RE: Principal Objection – DA2023/0681 at No. 19 Corkery Cres, ALLAMBIE HEIGHTS

Principal Objection per DA2023/0681

DA Address:	19 Corkery Crescent, ALLAMBIE HEIGHTS
DA Reference	DA2023/0681
Clients:	Mr Larry Ronald Delaney Mrs Lynette Myree Delaney Mr Mitchell James Delaney Mrs Gemma Louise Delaney (Co-owners of: No. 21 Corkery Crescent, ALLAMBIE HEIGHTS)
Stage	Principal Objection (Stage 2)
DA Description:	Demolition works and construction of a dwelling house.

Figure 3: Excerpts from DCP Section D1 (Source: *Warringah DCP 2011*)

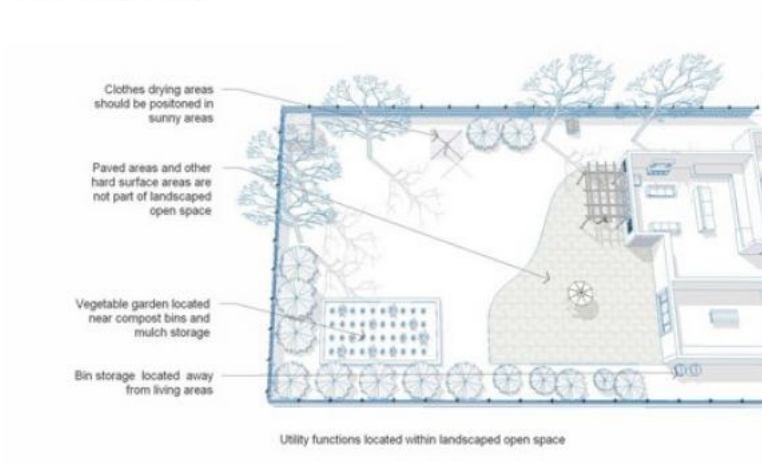
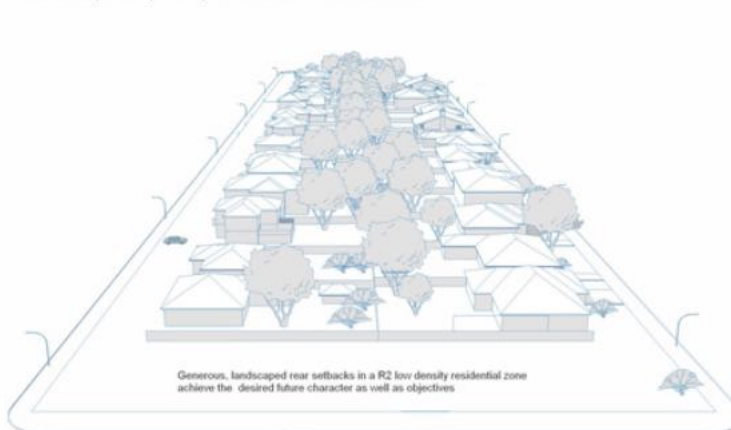
DCP Section D1 diagrams indicating the preferred siting and scale of vegetation for a typical low-density residential lot generally show large to medium-sized trees and shrubs in the front and rear setbacks, whilst small shrubs or NIL vegetation is indicated for side setbacks (see **Figure 3**). Photographic evidence of Corkery Crescent also underlines this preference, with the typical pattern of side boundary treatment apparent in the streetscape generally comprising of NIL or small-sized vegetation within side setbacks. As an example, **Figure 5** of the streetscape shows a preference towards locating medium to large-sized vegetation within either the front or rear building setbacks.

The proposed side boundary vegetation in contrast will contain a row of Magnolia Teddy Bear trees. Growing to a maximum height of three (3) metres and a diameter of 1.8-metres, this type of tree will likely block ambient light to habitable room windows of No. 21; impose an overbearing sense of enclosure; and require ongoing maintenance.

It is noted that the rear-most Magnolia has been sited within two (2) metres of the sewer, which may cause disruption to its proper functioning over time. Given this variety is known for its wide root system, the potential to cause lifting or damage to buildings elements or fencing is of concern.

The proposed side setback landscaping does not constitute small shrubs, and hence cannot comply with relevant DCP guidance, nor the predominant pattern within the streetscape. Given the possible harm these trees pose to property and local amenity, the Magnolia is thus considered inappropriate for the side setback.

Proposed Solution: That amended landscape plans be submitted showing small shrubs or NIL vegetation along the northern side setback.
